Access Compliance Report Public Rights-of-Way (Curb Ramps)

Intersection ID: 25269Main Street:REA_RDCross Street:SUMMER_GATE_DRLocation:SWADA ID: E3B6921DF84ERamp Type:Directional1Initial Pass/Fail:FailOverall Compliance:NoSeverity Score:1.25

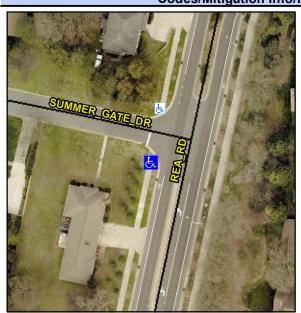
Possible Solutions:						
Remove & Replace Entire Ramp.						
Surveyor Notes:						
N/A						
BB0W/4B4						
PROW/ADA:						
R304.5.3
